PLANNING COMMISSION MEETING AGENDA REGULAR MEETING

PRELIMINARY SITE PLAN REVIEW (SU JPLN2023-0001) - Proposed New Tower Troy, Office Building and Parking Deck, East side of Troy Center Drive, South of Big Beaver, 755 Big Beaver Road (PIN 88-20-28-101-067), Section 28, Currently Zoned BB (Big Beaver) District

Re: New Tower, 755 W. Big Beaver Rd Preliminary Site Plan Review

NEW TOWER TROY

DRAWING TITLE **SITE PLAN WEST**

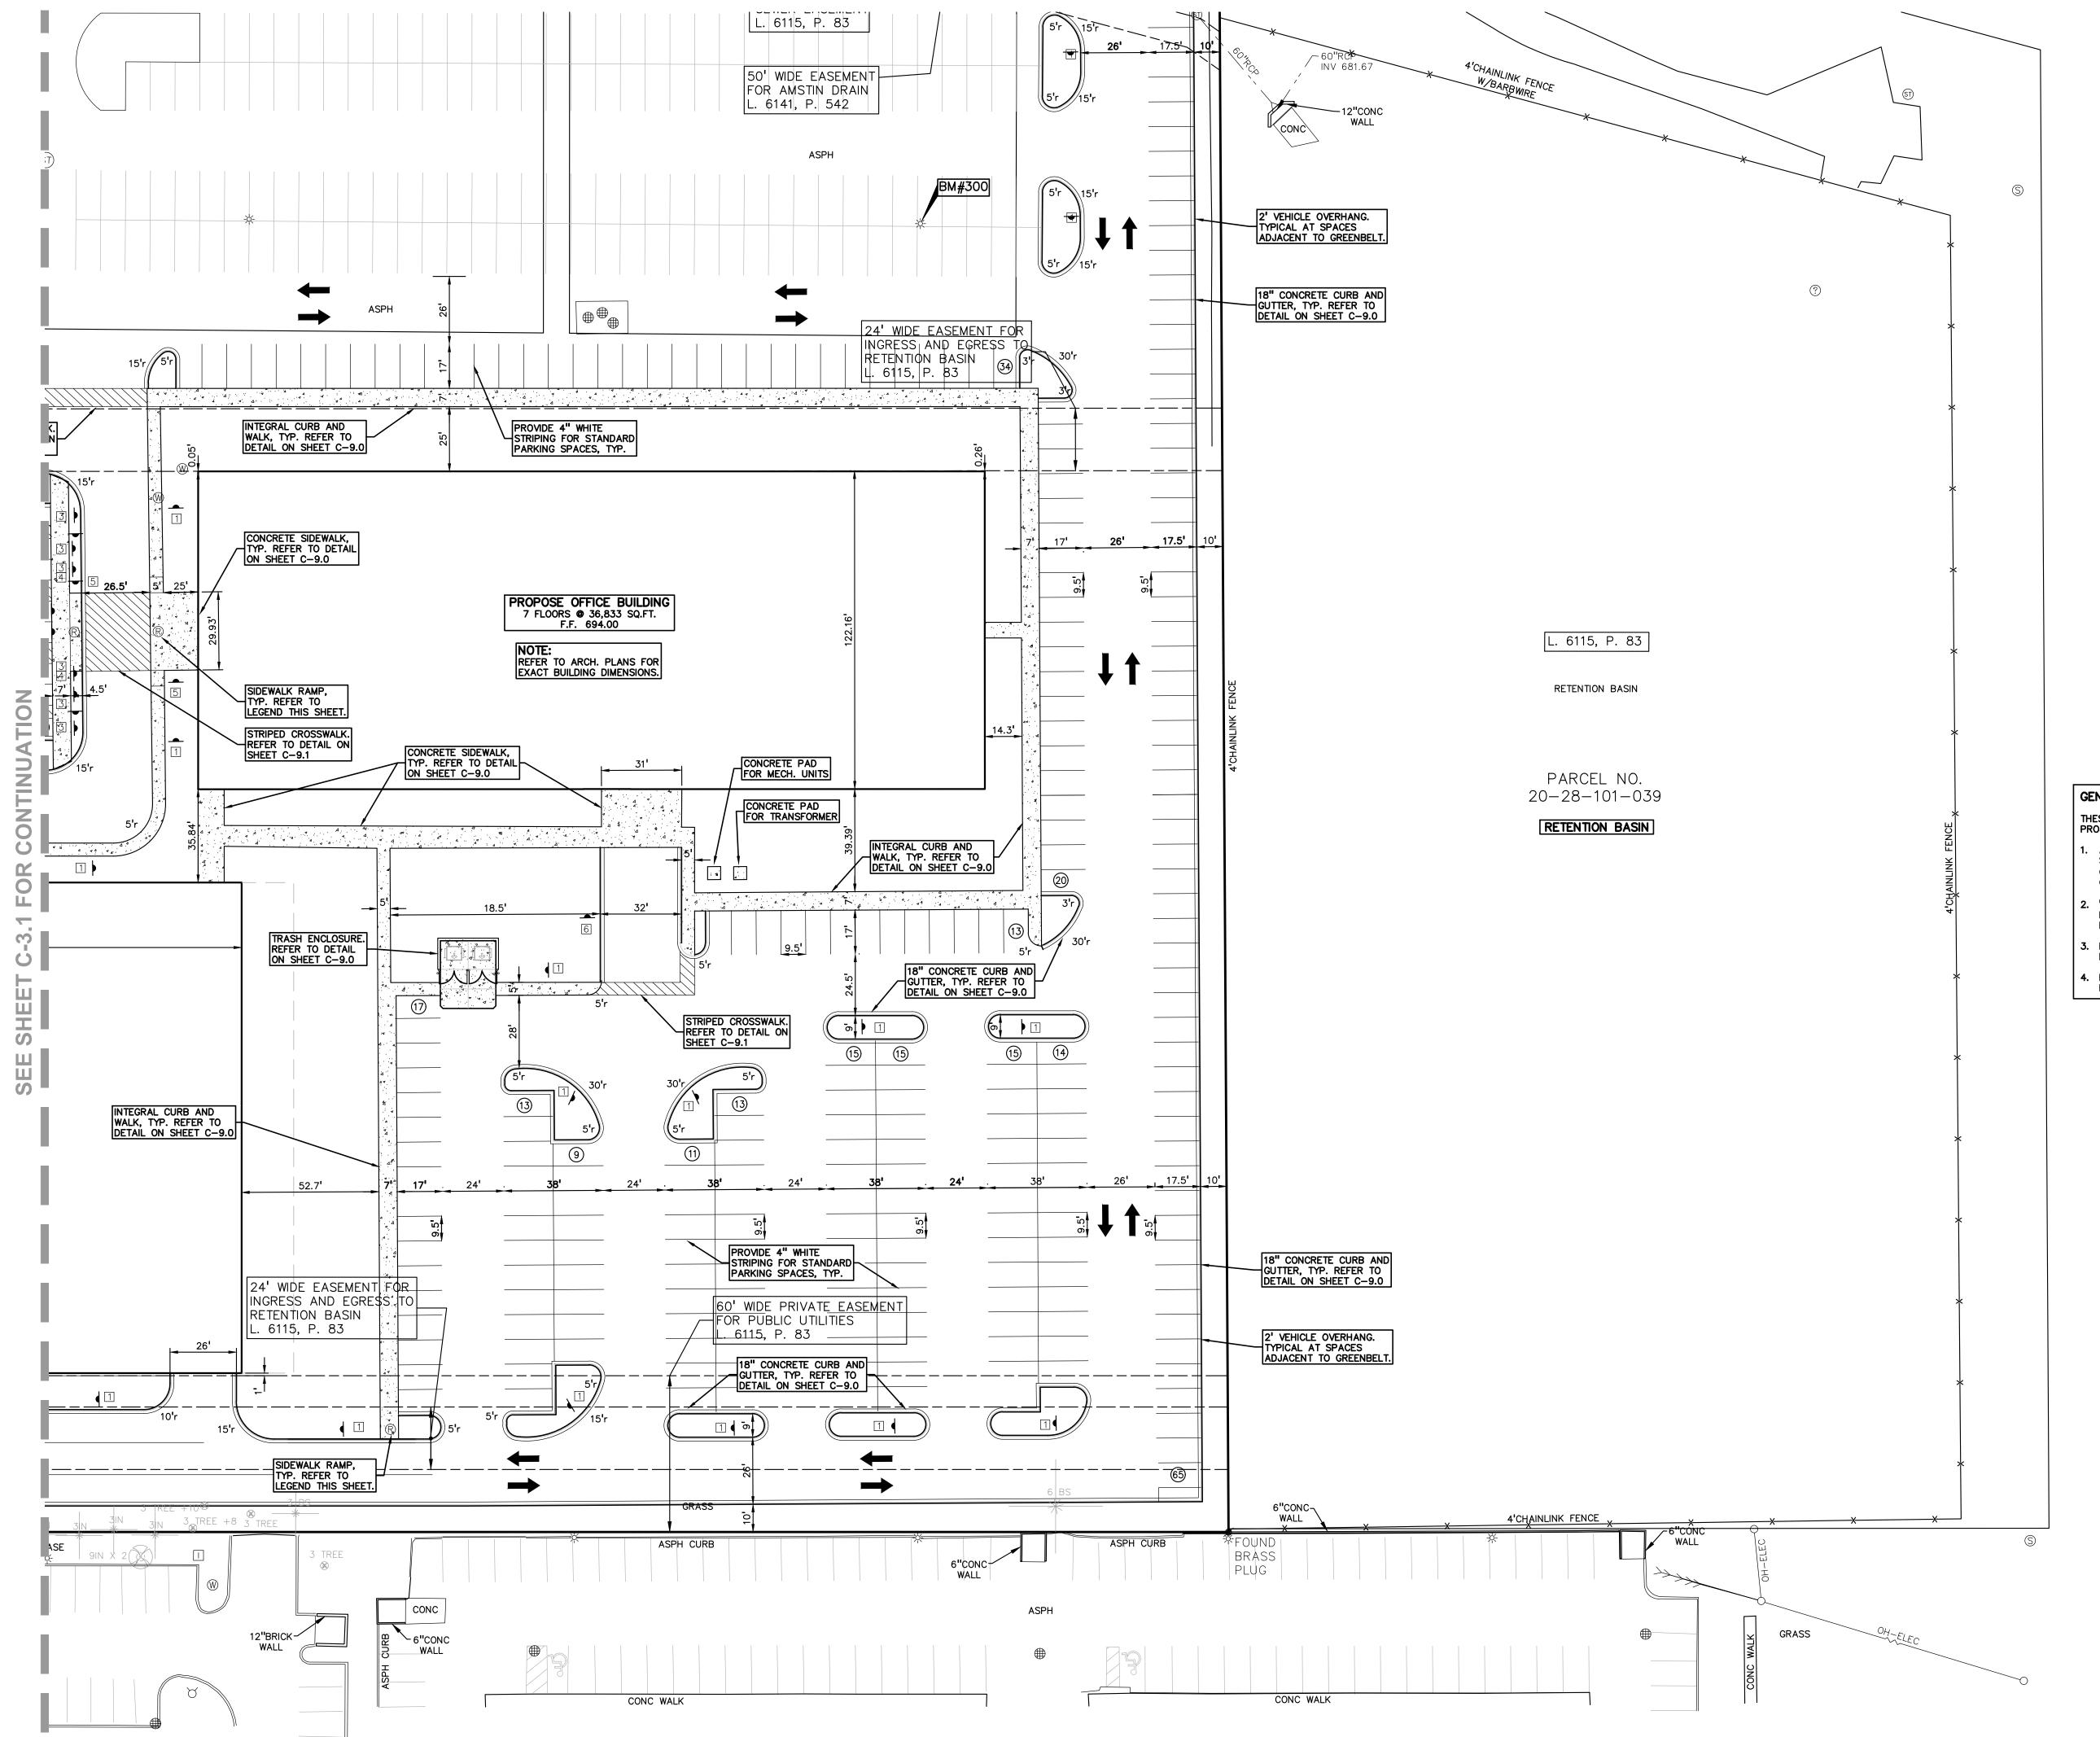
- a. The parking memo provided by Fleis & VandenBrink and the parking calculations on sheet C-1.0 and C-3.0 of the site plan do not match.
 - i. The parking memo includes 5,000 GFA of retail that is not listed on sheet C-3.0. The proposed parking deck plan shows 5,500 SF of first floor retail along Troy Center Drive, attached to the parking structure.

- ii. The floor area of PNC General Office versus PNC Medical/Dental Office does not match.
 - iii. The parking memo has the shared parking peak demand occurring at 10:00 am, while sheet C-3.0 on the site plan has the shared parking peak demand occurring at 11:00 am

- iv. With shared parking the parking memo shows a deficit of 204 parking spaces, while sheet C-1.0 and C-3.0 shows a deficit of 678 spaces and 569 parking spaces, respectively. While these numbers need to match, they both fail to meet the city ordinance.

OVERALL LANDSCAPE **PLAN**

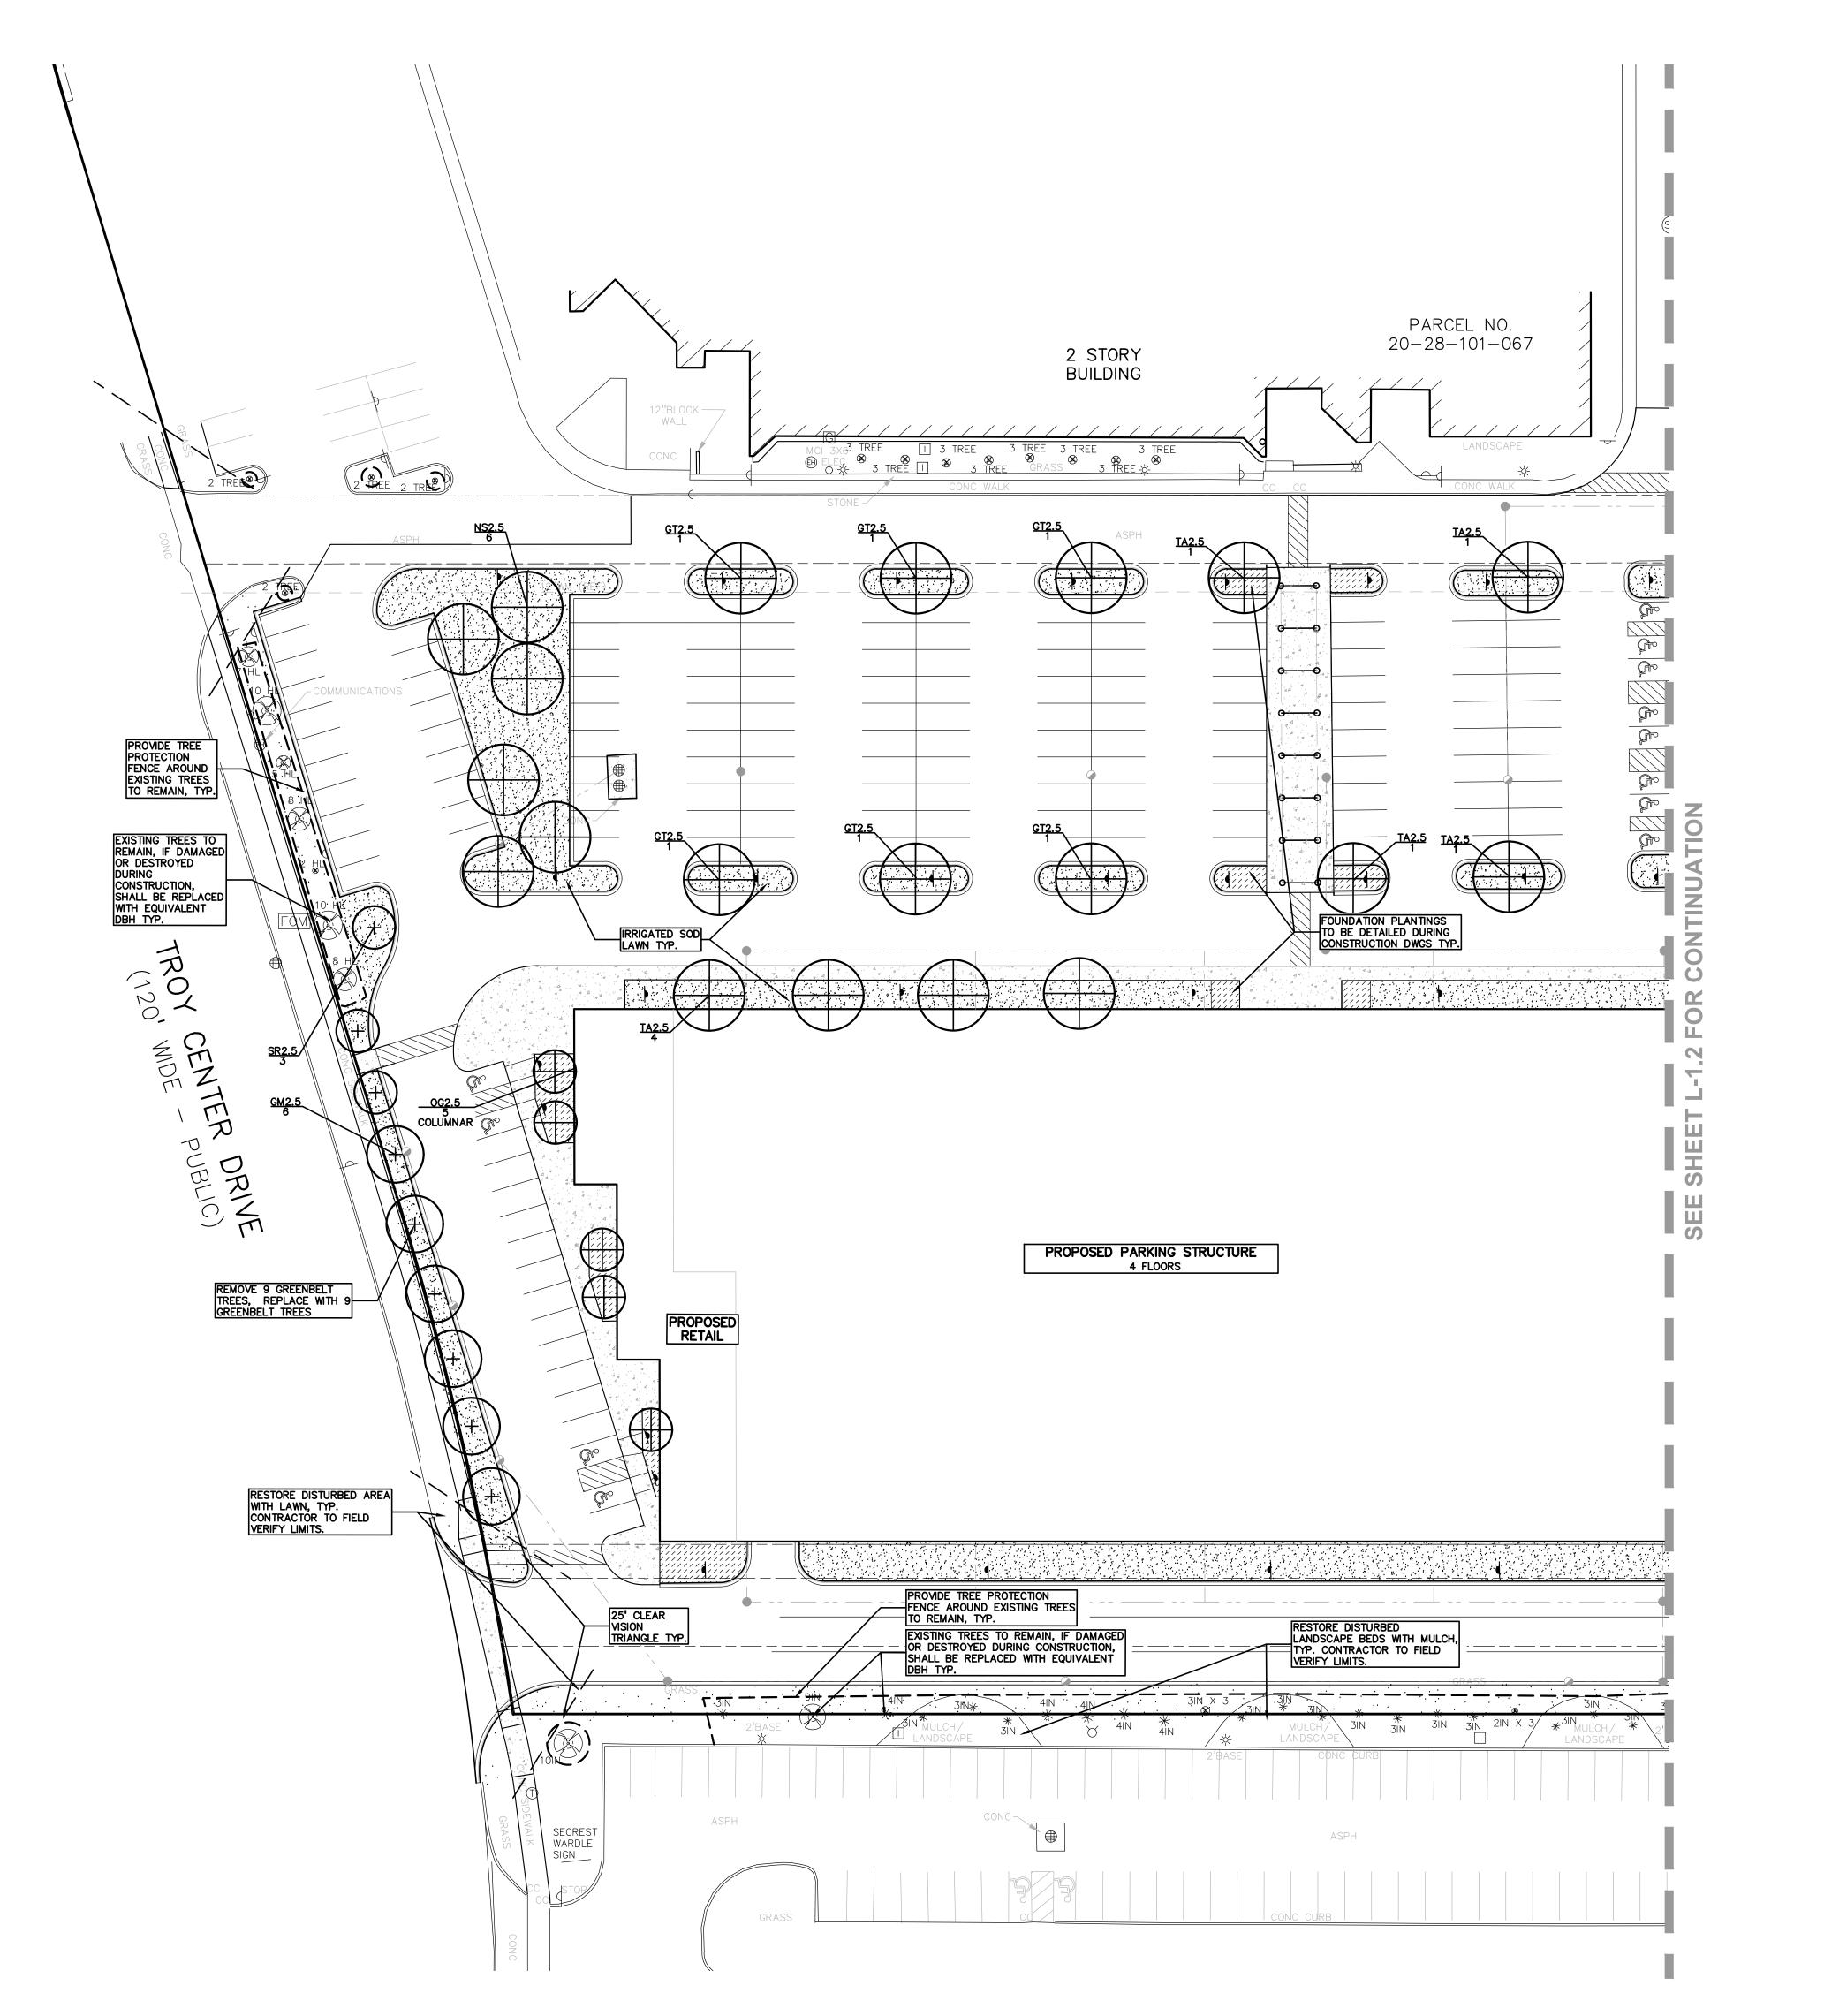
The applicant is required to provide fifty-two (52) parking lot trees. Twenty-eight (28) of the required fifty-two (52) are in parking lot and twenty-four (24) are along the perimeter of parking lot. Planning Commission may allow alternative location of parking lot trees.

Items to be Addressed: 1). Planning Commission to discuss parking lot tree location; 2). Provide trash enclosure screening details.
